# THE LAUNCH

## Concerns from the residents of El Portal

The Barrington Brothers development group, the builders of El Portal's first high-rise residential property (Kavista), have acquired the six residential properties/houses along the Little River, and plan to develop a second, eight (8) story building - The Launch - within that footprint, with site plans that should NOT be permitted in El Portal.

Excerpt from El Portal Village Code: Sec. 24-B.17.  
ZONE 5 (Z5) URBAN CENTER.

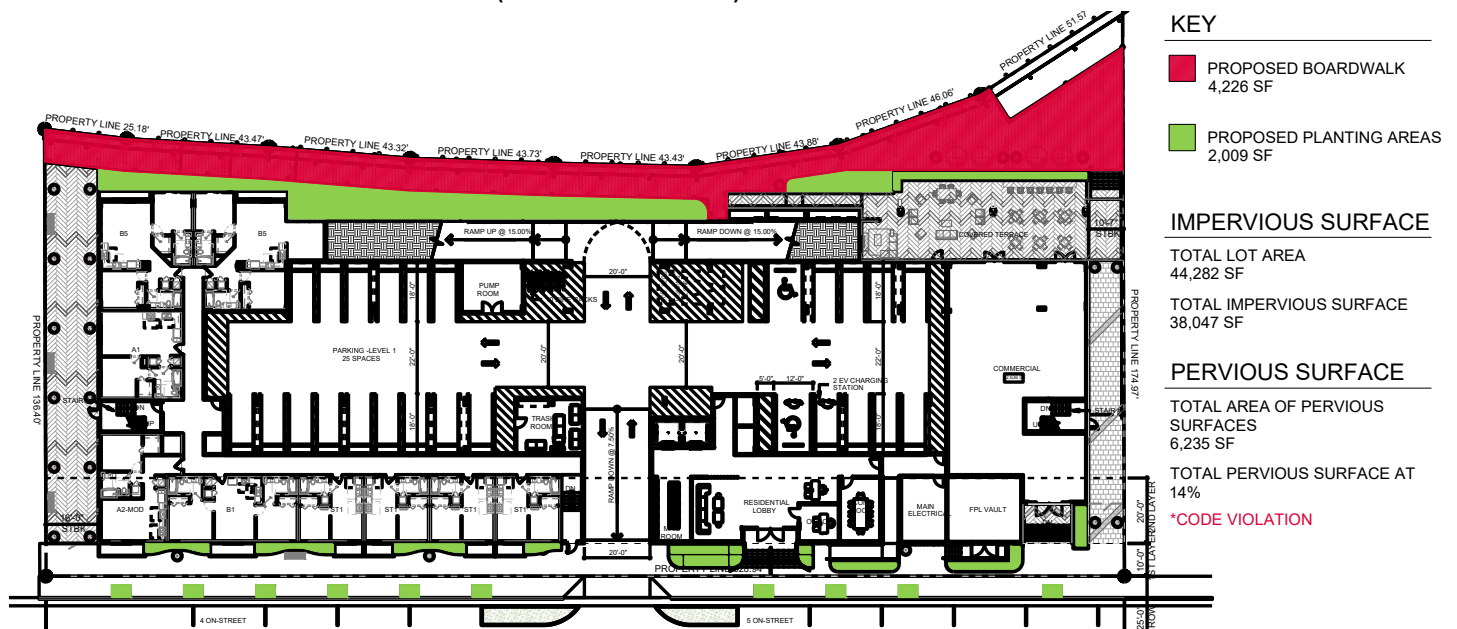
**1. Property is located within 250' of Z3, thus limited by code to 4 stories max. Site plans of 8 stories would violate section 24-B.17. - ZONE 5 (Z5) URBAN CENTER of El Portal Village Code.**

**No Benefit Height shall be permitted within 250' of Z3.**

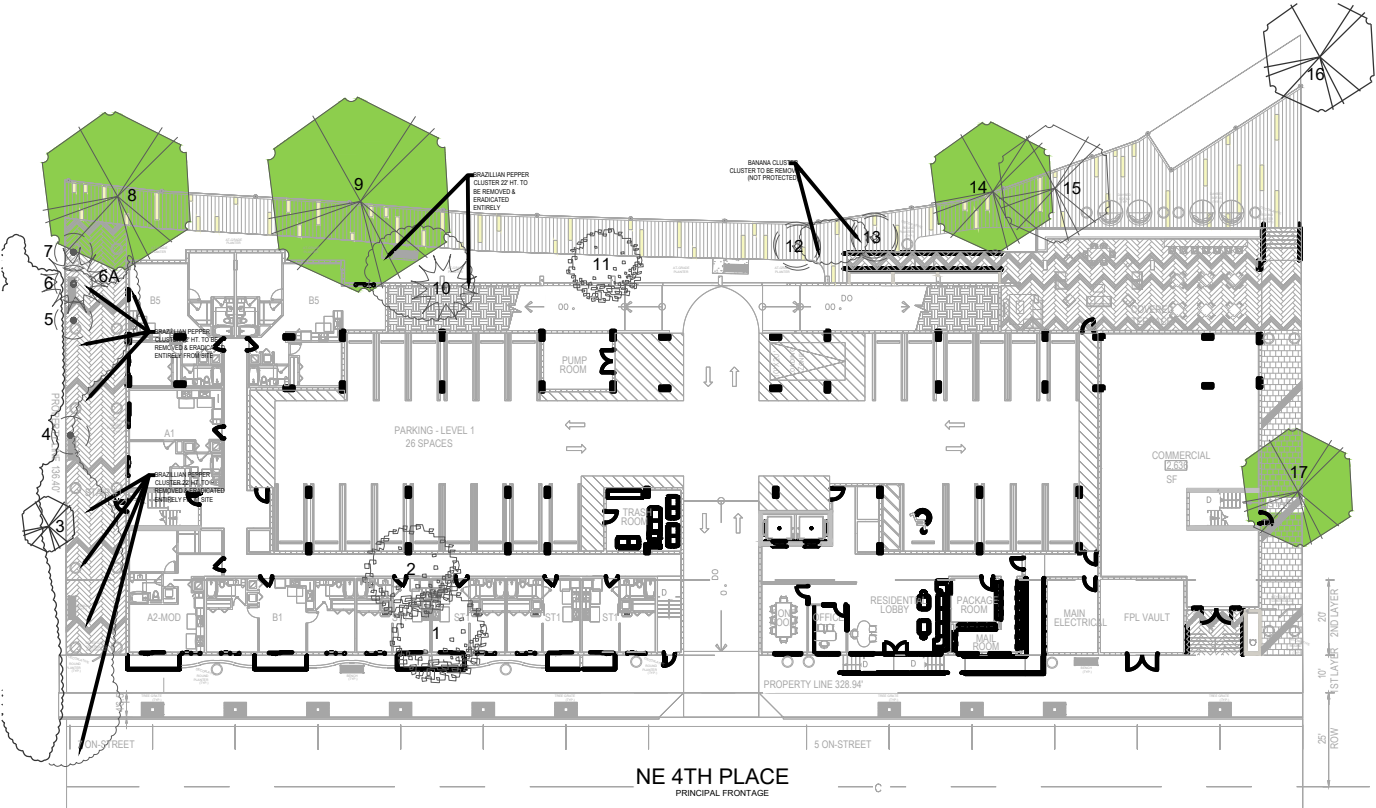
2) Site plans do not maintain 15% pervious landscaped, grass or natural coverage, in violation of 24-19(b) of El Portal Village Code. Please refer to Exhibit A (at the end of the document) for section 24-19 of El Portal Village Code Please refer to Exhibit B: (referenced below)

Total pervious surface at 14%.

Note\* The above image considers the wood decking (in red) as a pervious surface. It is not readily apparent in the plans what is under the wood deck. It shows the seawall, under the deck to some [unknown] degree, which would most likely be impervious. Considering this, please refer to Exhibit C to show the area of remaining pervious surface not including the wood deck.

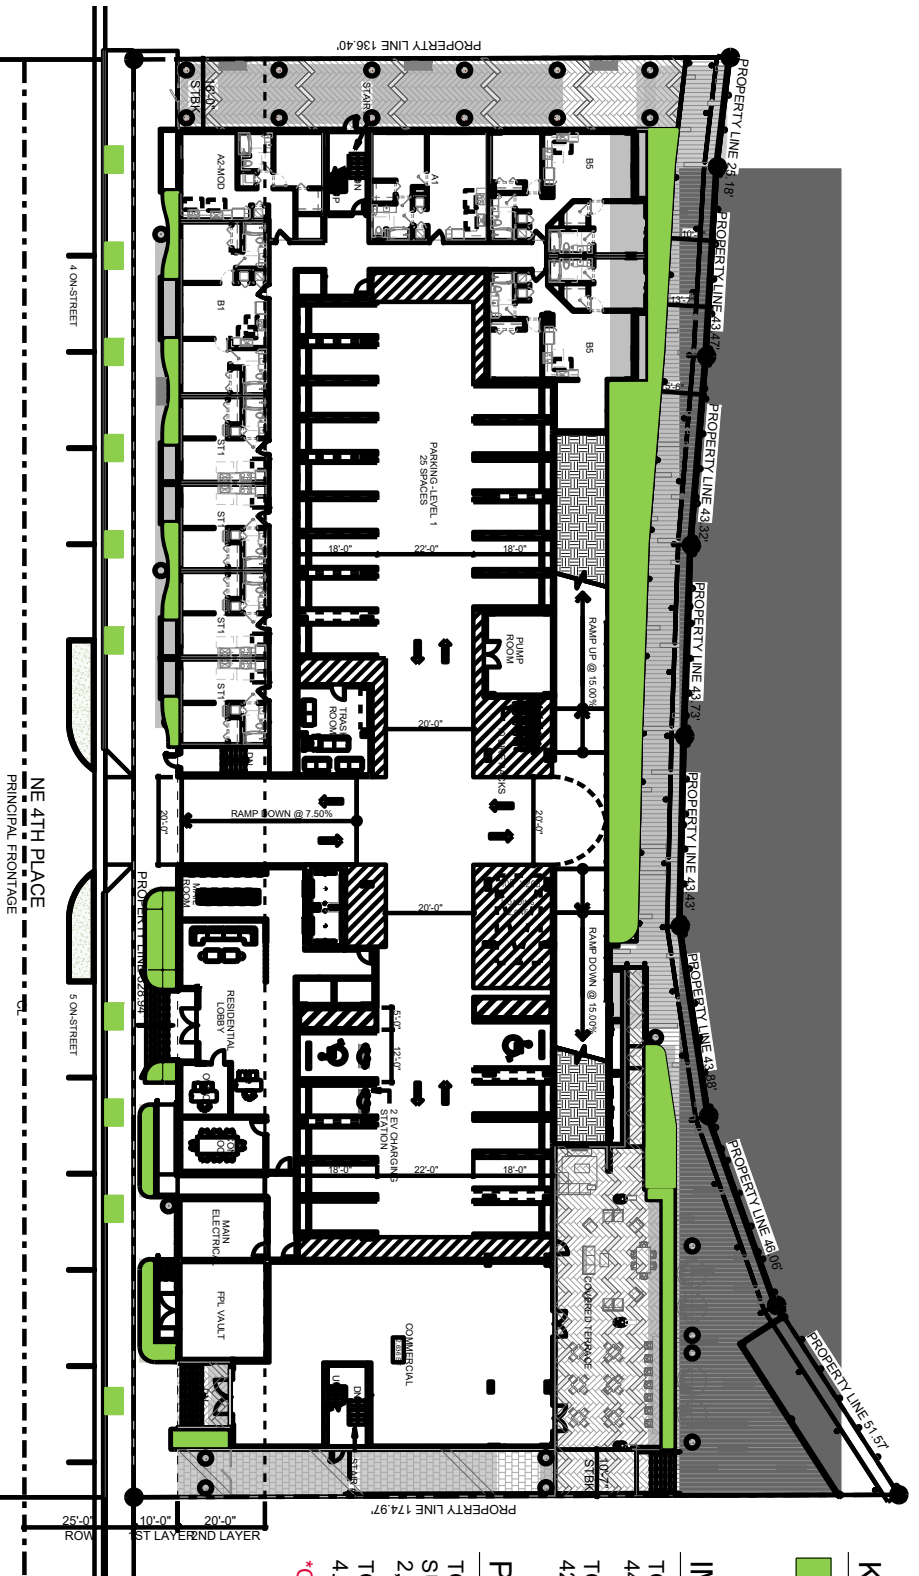
TOTAL PERVIOUS SURFACE AT  
14%

\*CODE VIOLATION

## Exhibit C:

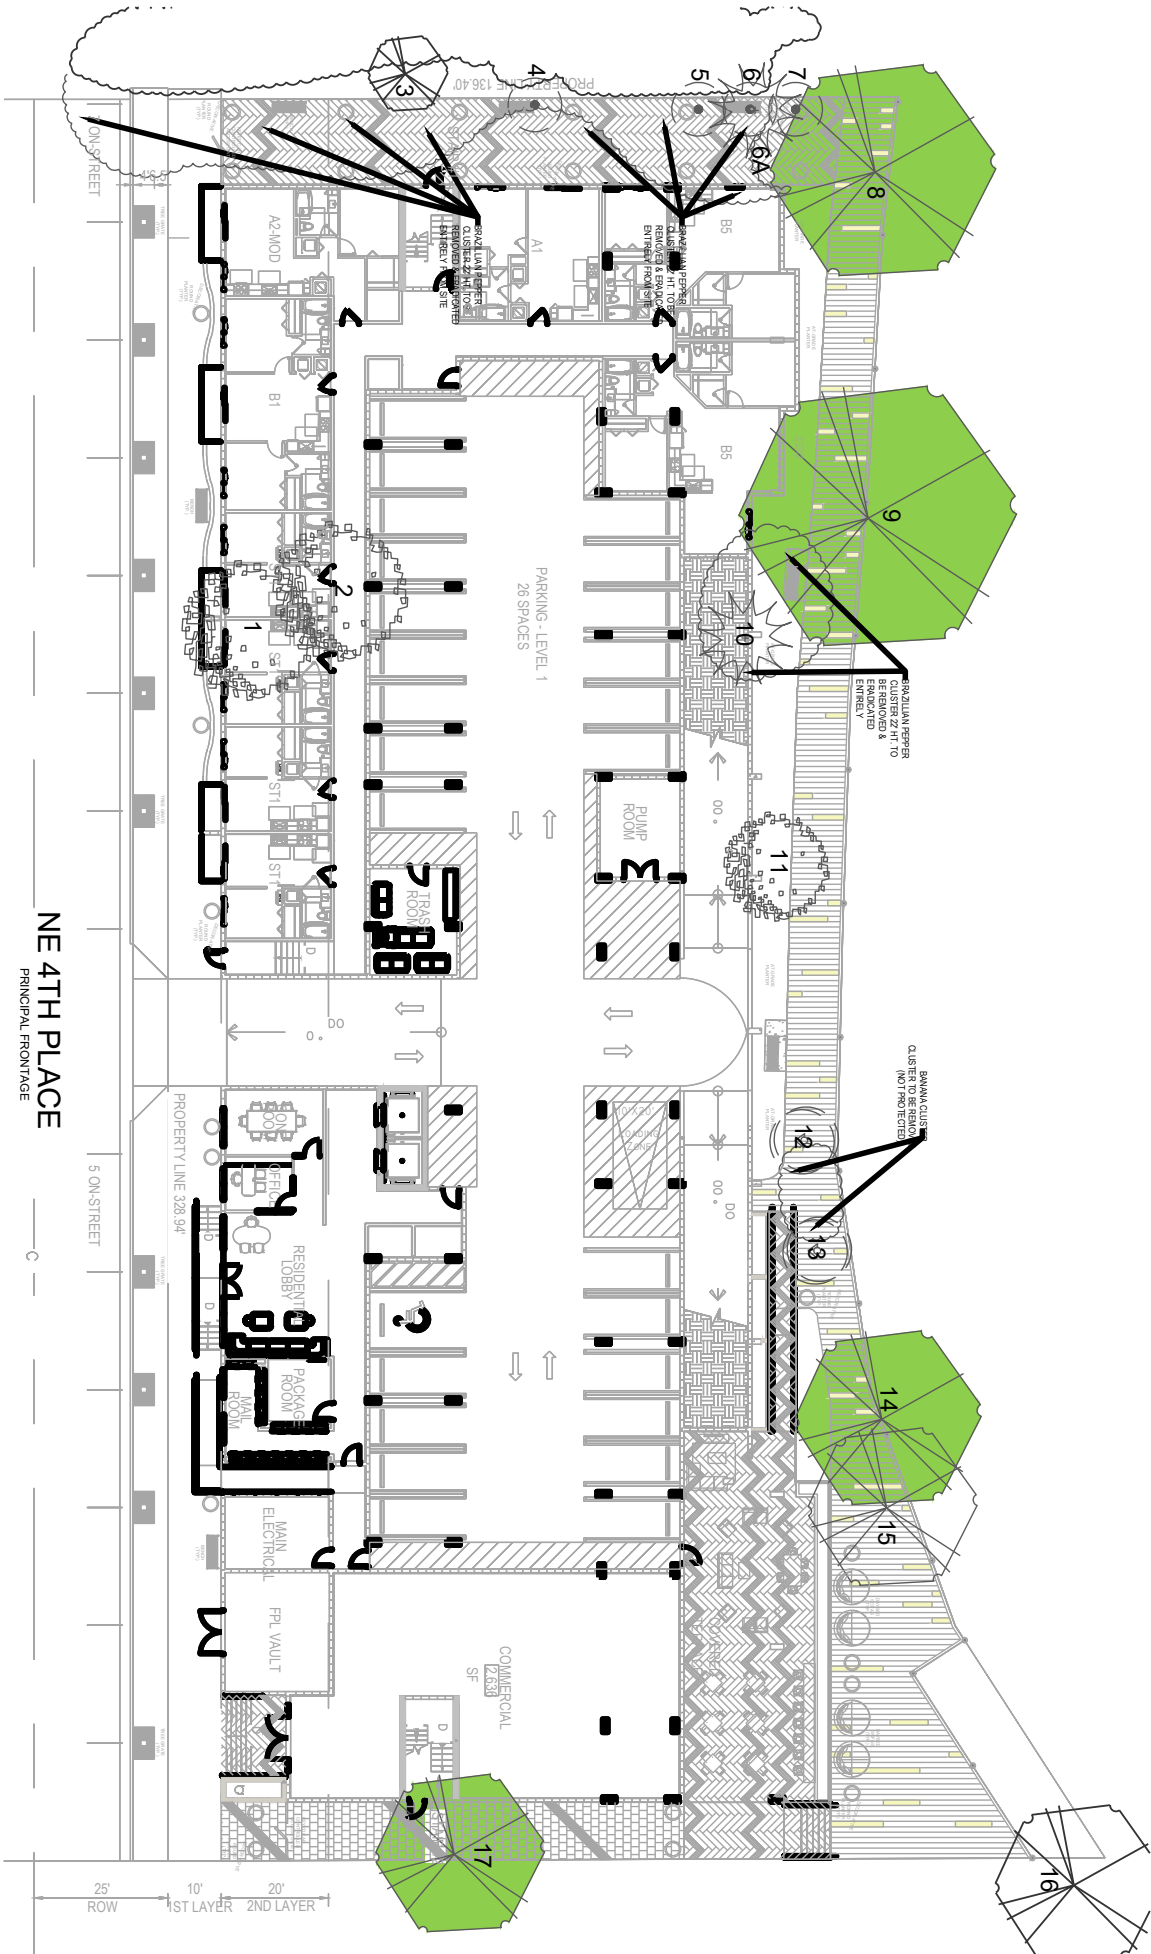
TOTAL PERVIOUS SURFACE AT  
4.5%

\*CODE VIOLATION
